Date February 10, 2021
To Town of Cumberland Planning Board
From Carla Nixon, Town Planner
Subject **Major (Final) Subdivision Review: Cumberland Crossing, Phase 2 - Tuttle and Greely Roads.**

Subject: Peer Review of Cumberland Crossing – Phase 2
Final Subdivision Plan Application
Tuttle Road & Greely Road, Cumberland, Maine

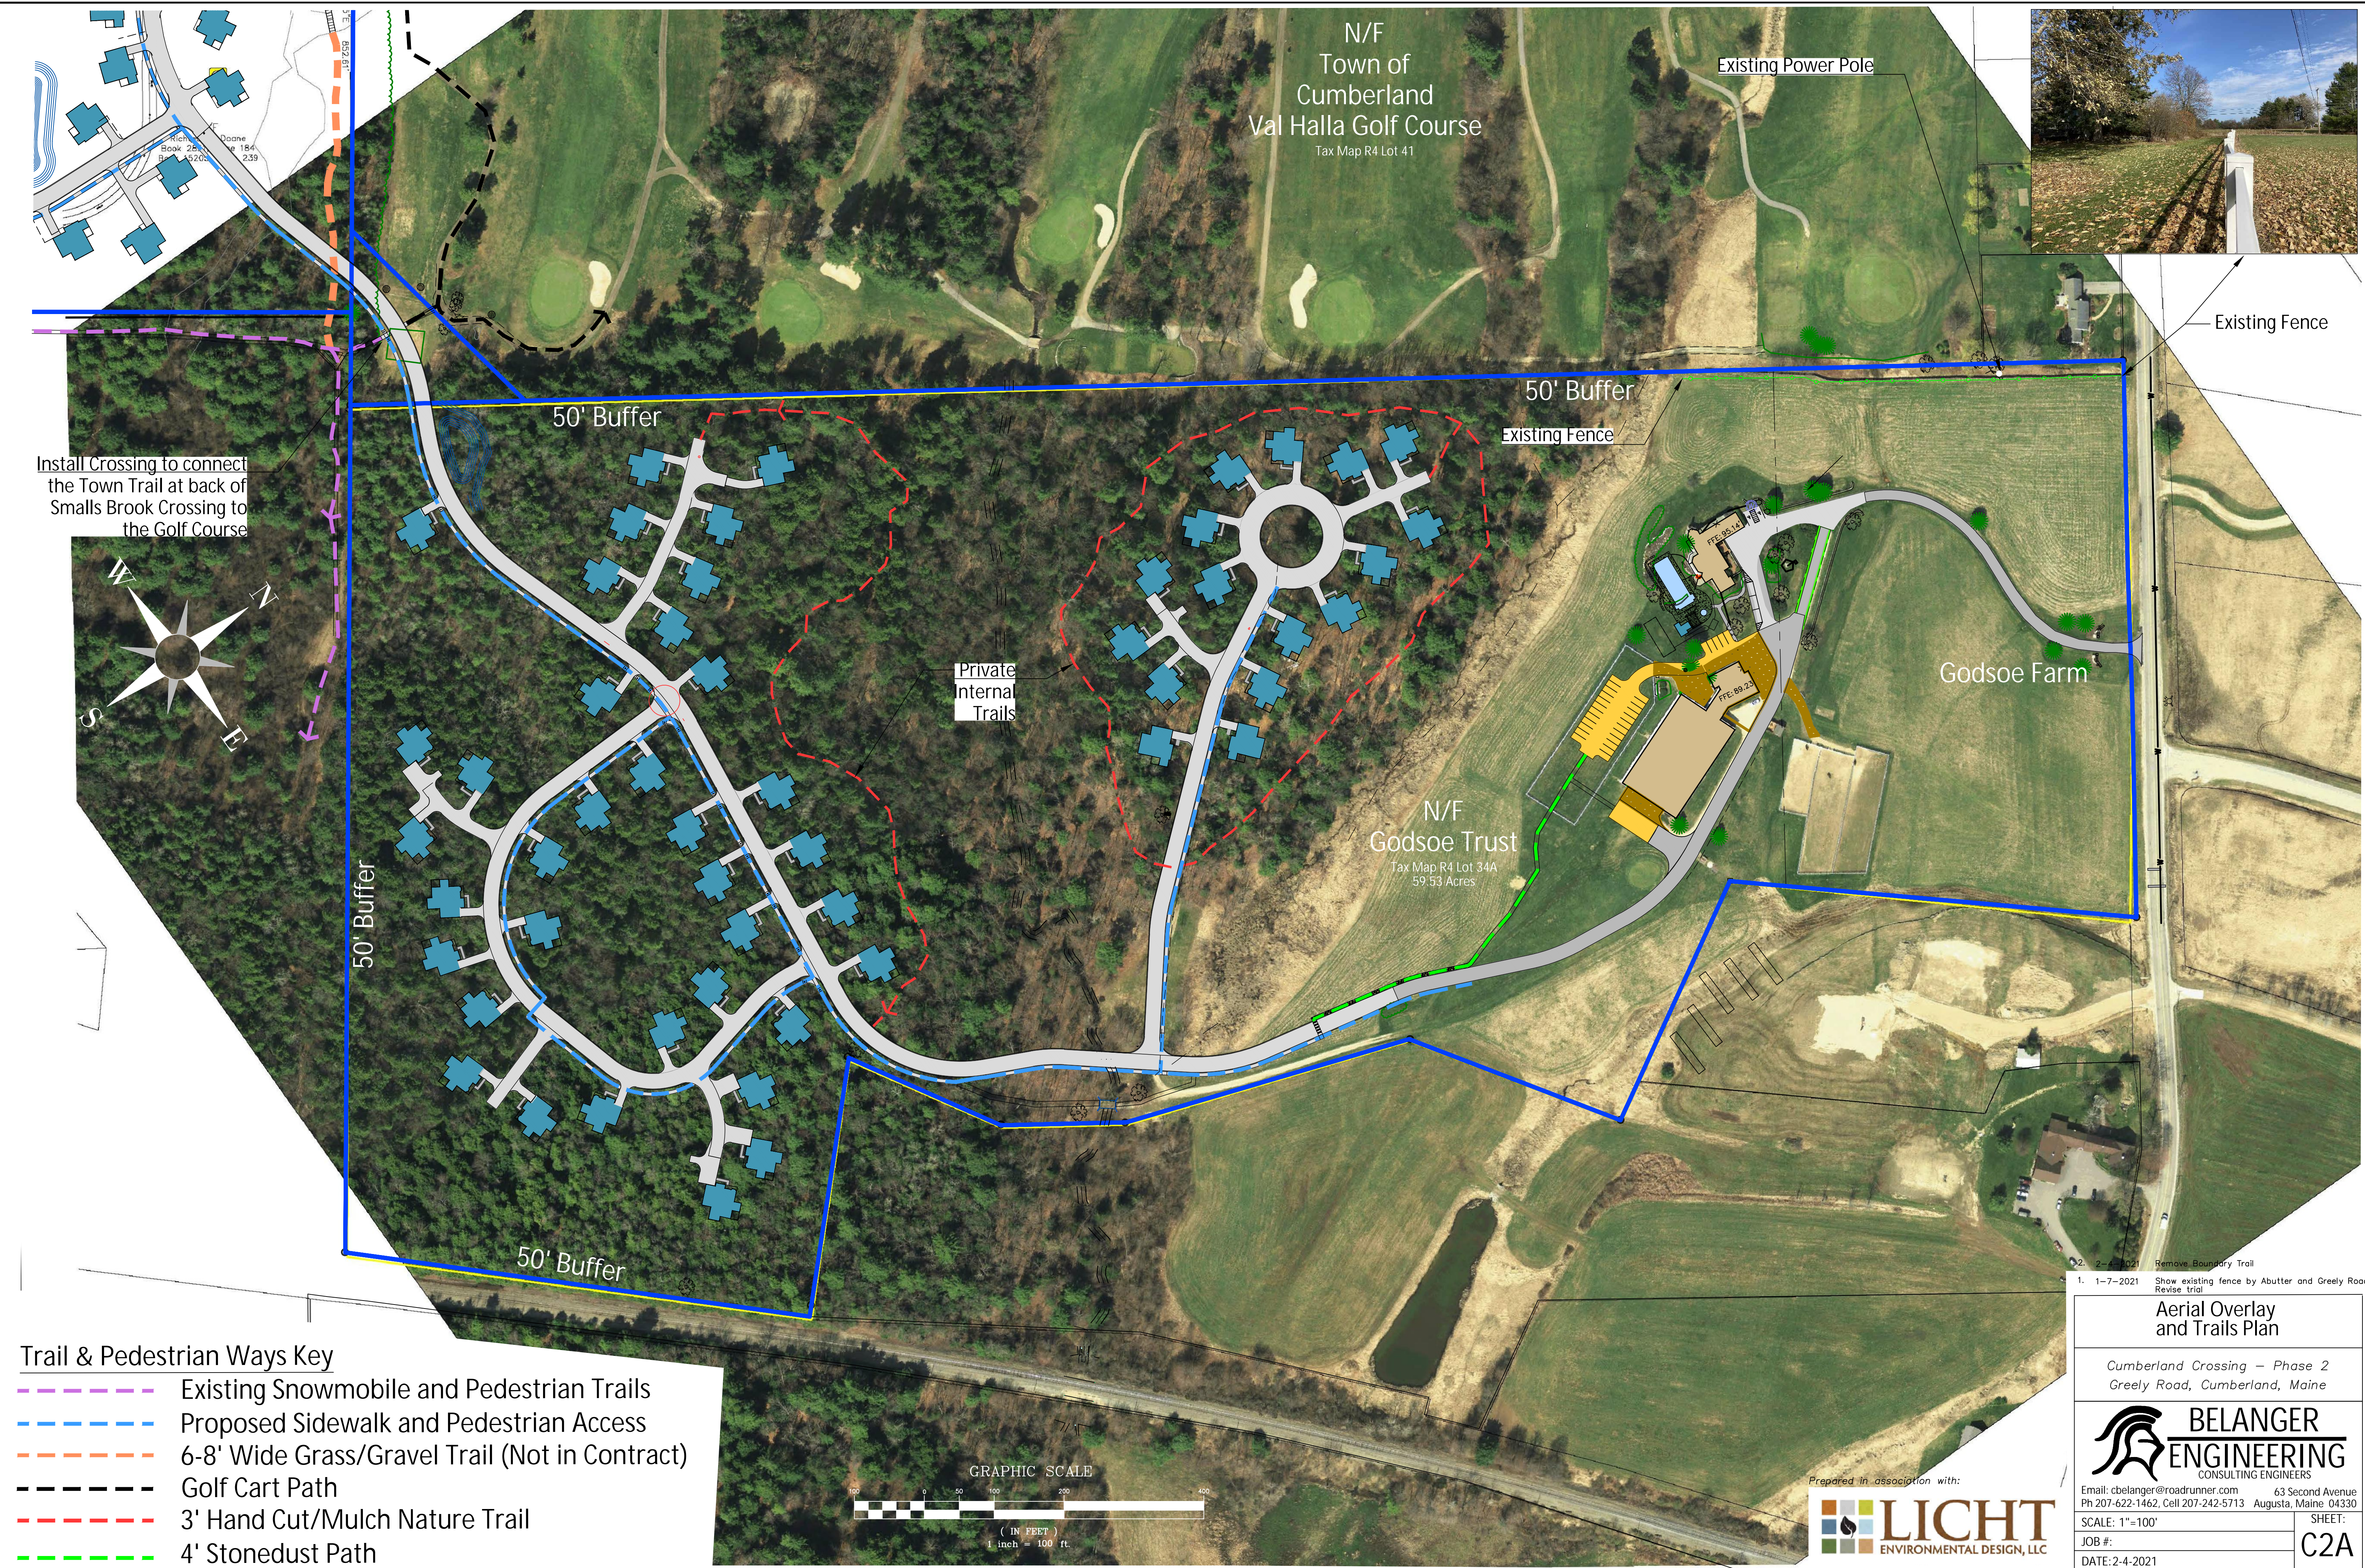
Furthermore, the developer has been informed multiple times that the “boundary” trail shown on the golf course is not acceptable to the Town due to safety concerns. This trail should be removed from the plans.

FIELD WK:	SCALE: 1"=40'	SHEET: C6C
DRN BY:	JOB #: 109	
CH'D BY:	SS:	
DATE: 12-18-2020	FILE:

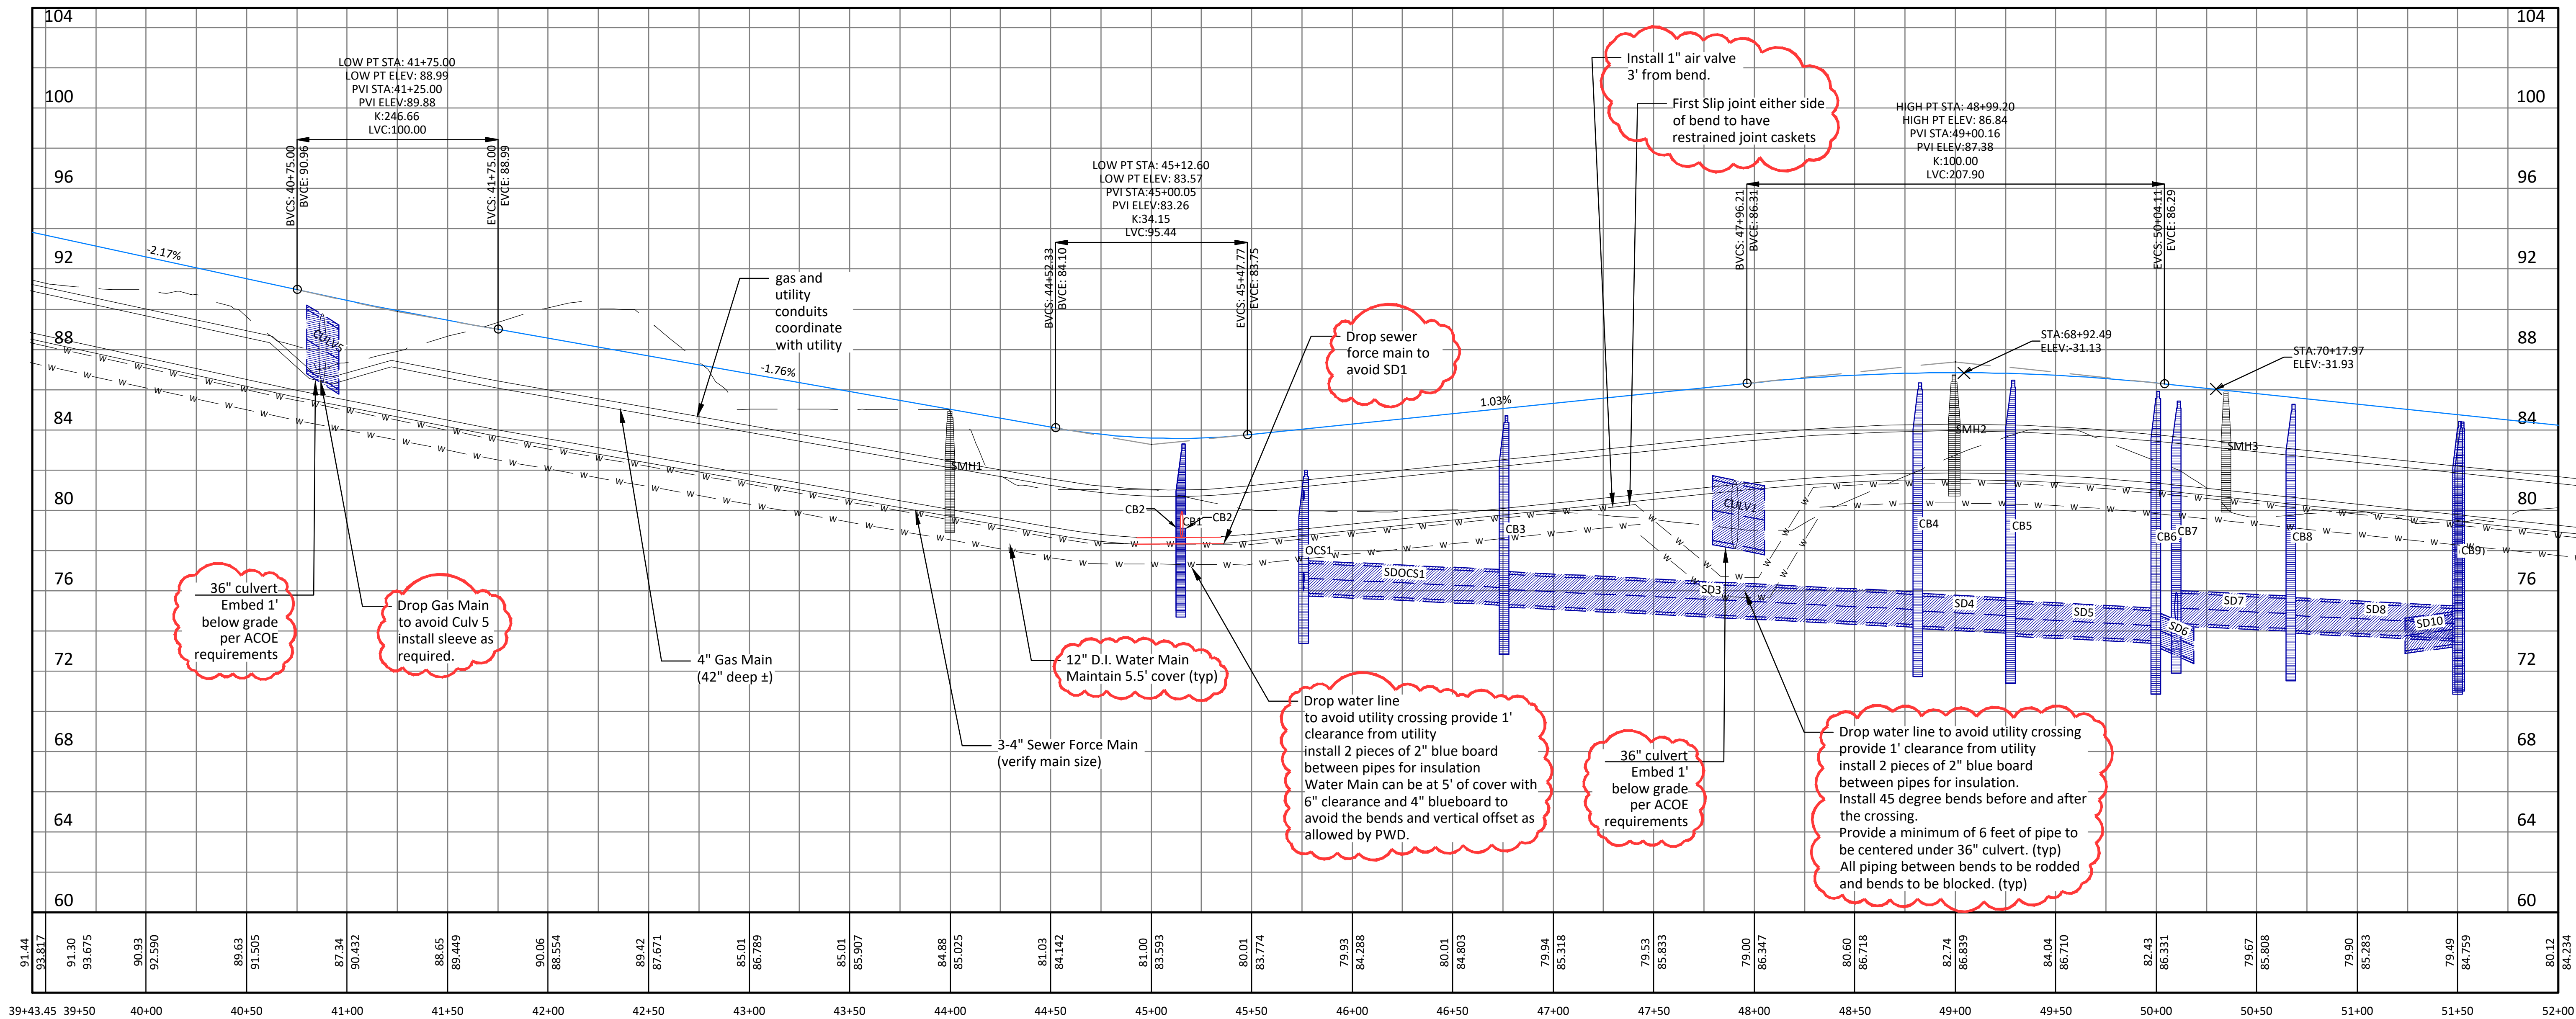
3. SME recommends that a flushing valve be added in SMH 1.
4. Plan Sheet 6C indicates that a 3 or 4-inch sewer force main be extended to Greely Road. Please clarify if the project intends to carry a 3-inch or 4-inch service.

8. Provide erosion and sedimentation control measures on Plan Sheet 6C for the Farm Area improvements, including stone check dams, silt fencing, etc.

12. Plan Sheet 6C – Please provide spot grades at the accessible parking area.
 13. Plan Sheet C7A – Please confirm cover over Culvert 5. It appears to be less than 2-feet and will conflict with the proposed gas main. SME understands this will be included in the Final Plan.
